Reviewer #1

Ponds et al. explore how a non-stationary model parameter (root zone storage capacity) will impact streamflow in humid (energy-limited) catchments under future climate scenarios. My understanding is that previous work from the coauthors has used the same model and the same data to explore the impact of future climate scenarios in the same catchments (Bouaziz et al. and Hanus et al.). Thus, this contribution's impact hinges on what we learn about nature/how the world works by exploring the implications for streamflow of changing a single parameter (S_r) in an existing hydrological model in a particular climate type.

Figure 1- Overview of 3000 best parameter ranges by HRU by catchment. Please note: axis vary by HRU.

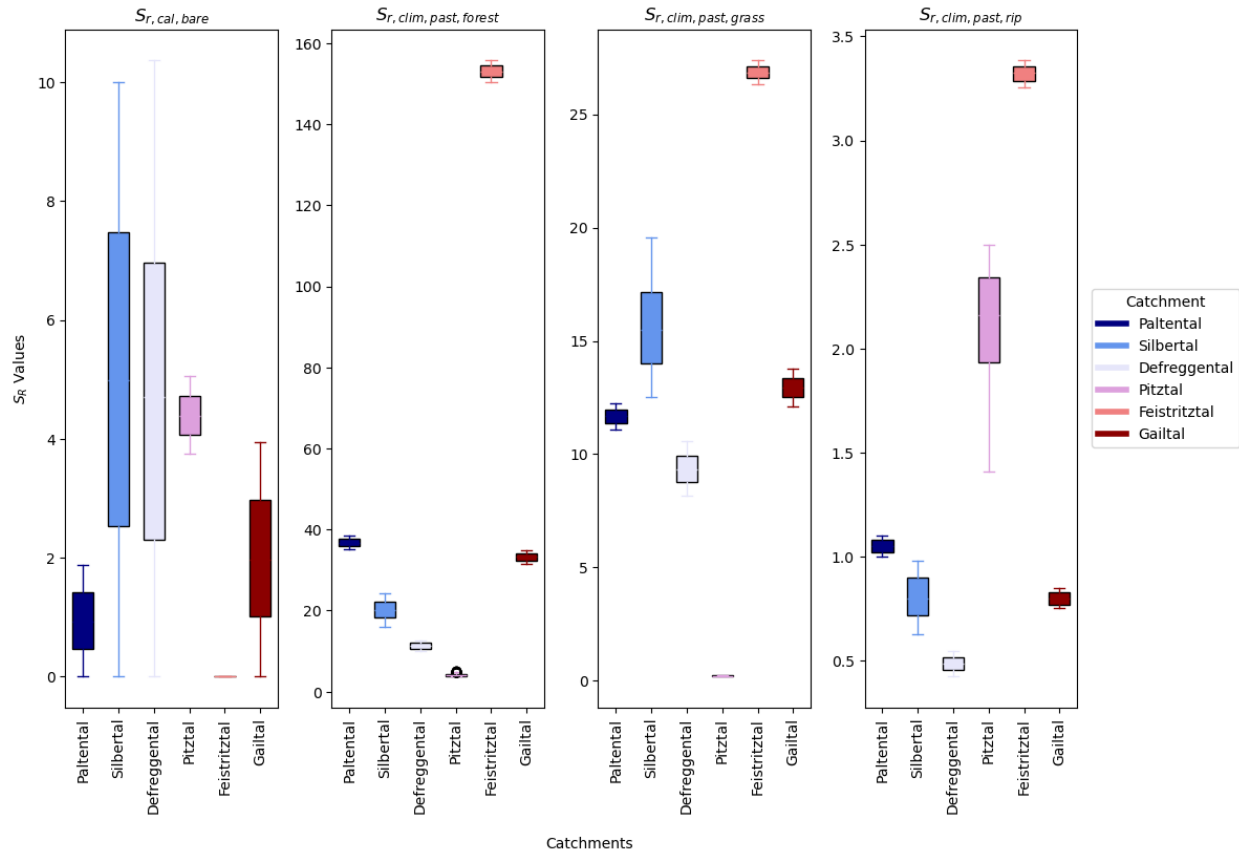
The study adopts the assumption that roots will be able to grow as much or as little as needed to obtain water to overcome droughts of a particular recurrence interval, without consideration to how substrate may limit rooting. The studied include glaciers (and presumably, large expanses of

exposed, relatively fresh bedrock, whose area grows under the future climate scenarios in which warming has resulted in glacier retreat). It is not clear that this assumption is realistic for the study catchments.

Two of the study catchments indeed include glaciers, accounting for 1.5 and 18% of the respective catchment areas (Table 1 in the original manuscript). The glaciers are represented in the model HRU referred to as “Bare Rock/Sparsely vegetated” (Supplementary Material Fig.S1). The past and estimated future glacier retreat, as described in Section 2.2.1 in the original manuscript, is accounted for by changing areal fractions over time as described by variable A_{GI} [-] (Supplementary Material Tab.S1). The fraction of the HRU “Bare Rock/Sparsely vegetated” that is covered by glacier (A_{GI}) is assumed to have a perennial snow pack that allows continuous melt on days with temperatures exceeding the threshold temperature T_{Thres} , thereby assuming a *de facto* “infinite” snow water storage. The fraction not covered by glacier ($1-A_{GI}$) can only generate snow melt as long as a seasonal/transient snow pack is present.

In absence of significant vegetation, this bare rock HRU is characterized by very low root zone storage capacities $S_{R,bare} < 10$ mm that also include surface/rock interception. Ranges and best parameter values (3000 per catchment) per HRU are displayed respectively in Figure 1 below.

Please note that for the bare storage capacity parameter, no adjustments are made from the calibration, which is why the subscript remains $S_{R,cal,bare}$. In contrast, the other parameters are recalculated using the memory method, represented as $S_{R,clim,...}$.
